Access Compliance Report

Public Rights-of-Way

(Curb Ramps)

Intersection ID: 3258	Main Street: GLEN HOPE LN	Cross Street: SHADOW PINE DR	Location:	N
ADA ID: 2234A6137FE3	Ramp Type: Perp	Initial Pass/Fail: Fail	Overall Compliance: No	Severity Score: 10

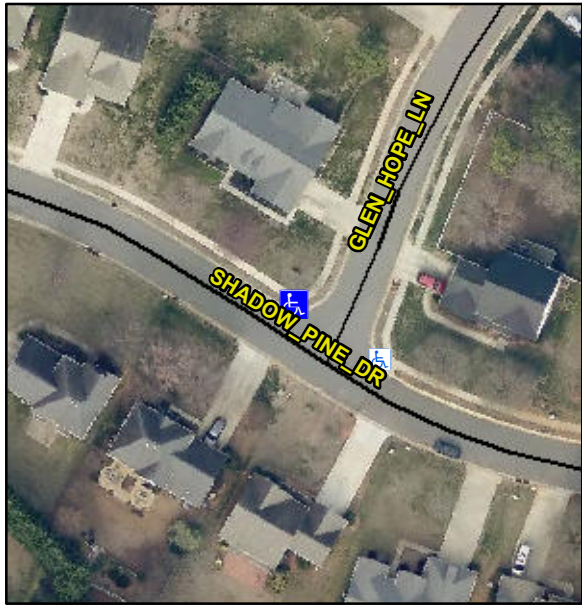
Codes/Mitigation Info/Possible Solution			Field Measurements/Component Compliance					
	Possible Solutions:		Compliance	Description	Data	Compliance	Description	Data
	Remove & Replace Entire Ramp.		N/A	Ramp Length (in)	42.0	Yes	Ramp Slope (%)	5.1
			No	Ramp Width (in)	36.0	No	Ramp XSlope (%)	3.0
			N/A	Flare Type LT	N/A	N/A	Flare Type RT	N/A
			N/A	Flare Slope LT (%)	N/A	N/A	Flare Slope RT (%)	N/A
			N/A	Flare Traversable LT?	N/A	N/A	Flare Traversable RT?	N/A
			N/A	Landing Length (in)	N/A	N/A	DWS Provided?	N/A
			N/A	Landing Width (in)	N/A	N/A	DWS Contrast?	N/A
			N/A	Landing Slope (%)	N/A	N/A	DWS Length (in)	N/A
			N/A	Landing X Slope (%)	N/A	N/A	DWS Full Width?	N/A
Surveyor Notes:			N/A	Landing Curb? (Y/N)	N/A	N/A	DWS Offset (in)	N/A
N/A			N/A	Shared Landing?	N/A			
PROW/ADA:			N/A	Gutter Ponding?	N/A	N/A	Gutter Slope (%)	N/A
Not Found, R304.5.1, R304.5.3			N/A	Gutter Lip Ht (in)	N/A	N/A	Gutter X Slope (%)	N/A
